# EBMUD WEST OF HILLS NORTHERN PIPELINES PROJECT

Response to Comments Document

East Bay Municipal Utility District

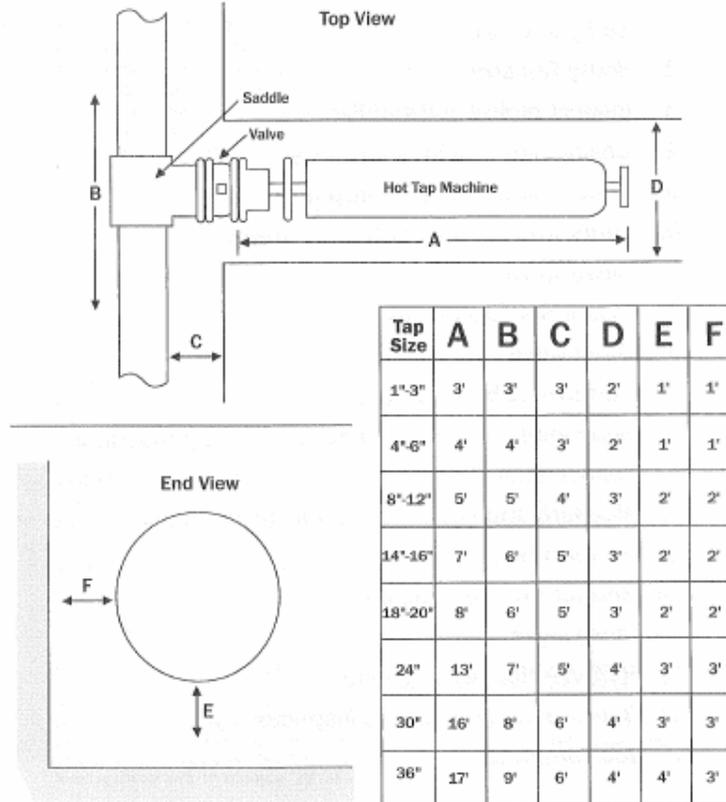
BERK-04 This comment requests additional description of the hot tap connections described on DEIR page 2-32. To supplement the written description of the hot tap connection procedure, the following photographs and figure are provided:

**Figure 3.11-2**  
 Noise Measurement Locations for Wildcat Pipeline (El Cerrito)  
 and Central Pressure Zone Pipeline (El Cerrito and Richmond)

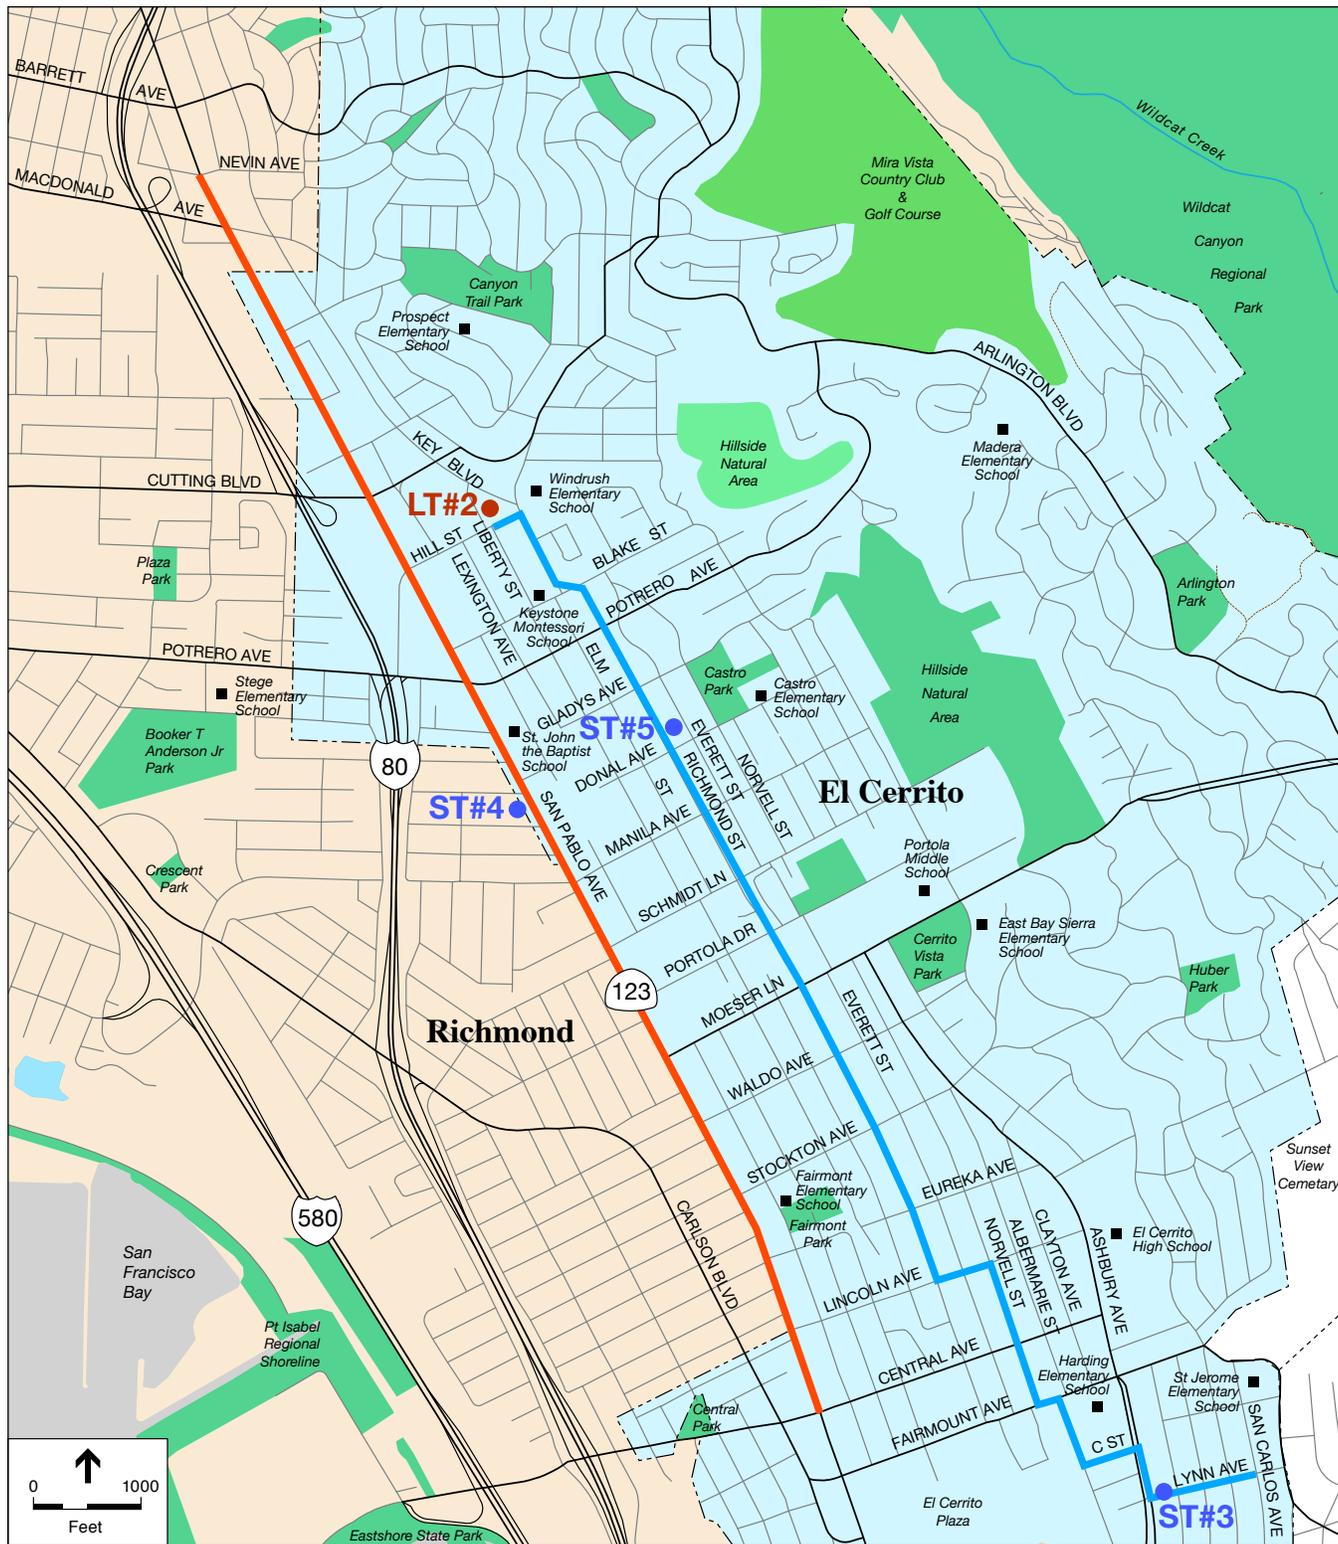
ELCERR-07 The comment points out facilities not identified, or incorrectly identified, on Figure 3.11-2 (DEIR page 3.11-4). Preschools and community centers are not identified on Figures 3.11-1 through 3.11-3, only parks and schools.

In response, DEIR Figure 3.11-2 has been revised to delete the Casa Cerrito Recreation Center and add St. John the Baptist School (see page 3-34).

Figure 3.11-2, Noise Measurement Locations for Wildcat Pipeline (El Cerrito) and Central Pressure Zone Pipeline (El Cerrito and Richmond) on page 3.11-4 is revised, as shown on the following page.

**Figure TC-5**  
Proposed Detour Routes  
Wildcat Pipeline (El Cerrito)

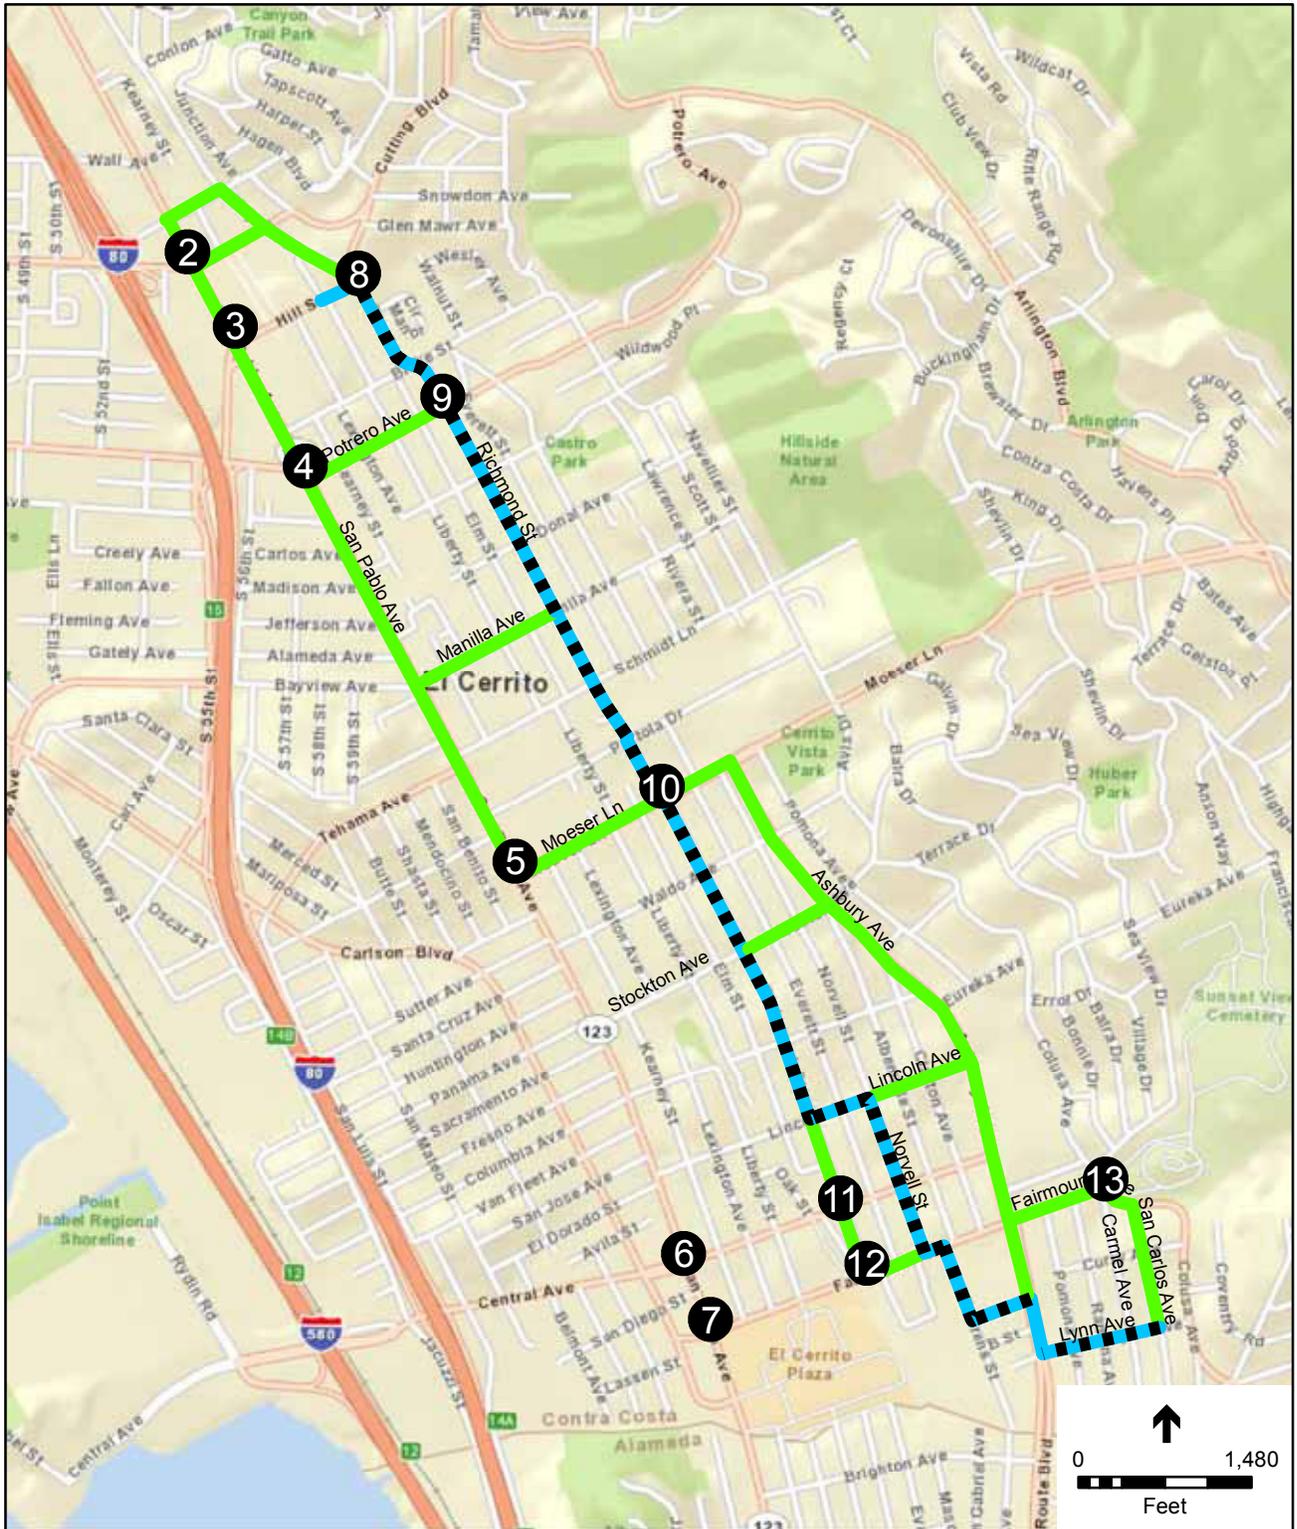
Regarding the comments on detour routing, the detour routes analyzed in the DEIR were selected with input by the City of El Cerrito staff. Note that Pomona Avenue is not proposed as a detour route (see Figure TC-5 in Appendix D and revised text below); Colusa and Fairmount Avenues could be used as a detour route for Lynn Avenue in place of San Carlos Avenue; Central Avenue (via Richmond Street or Ashbury Avenue) could be used as a detour route for closure of the block of Fairmount between Norvell and Behrens Streets in lieu of Lincoln Avenue; and detours are identified for Lynn Avenue (see Table 2-9 and Figure TC-5, ) although EBMUD proposes to keep one lane of Hill Street open during construction hours (DEIR page 3.13-20). Conceptual traffic control figure TC-5 has been revised to correct an error (see revised figure on page 3-36 of this document). As indicated in the legend on Figure TC-8, the intended detour routes along Lexington Avenue and Lincoln Avenue were intended to serve only the eastbound left-turn Central Avenue automobile traffic at the San Pablo Avenue/Central Avenue intersection during the pipeline tie-in at the intersection. Due to City staff concerns about routing traffic through the residential neighborhood, Carlson Boulevard could be considered for use as an alternate route for all the eastbound left-turn traffic including automobiles, buses and trucks. Carlson Boulevard has adequate roadway

capacity to accommodate traffic detours and the conceptual traffic control figure TC-8 has been revised to reflect this request (see revised figure on page 3-37).

Figure TC-5, Proposed Detour Routes, Wildcat Pipeline (El Cerrito) and Figure TC-8, Proposed Detour Routes Central Pressure Zone Pipeline (El Cerrito/Richmond) in Appendix D are revised as shown on pages 3-36 and 37.

Figure TC-5, Proposed Detour Routes, Wildcat Pipeline (El Cerrito) and Figure TC-8, Proposed Detour Routes Central Pressure Zone Pipeline (El Cerrito/Richmond) are revised, as shown on the following pages.
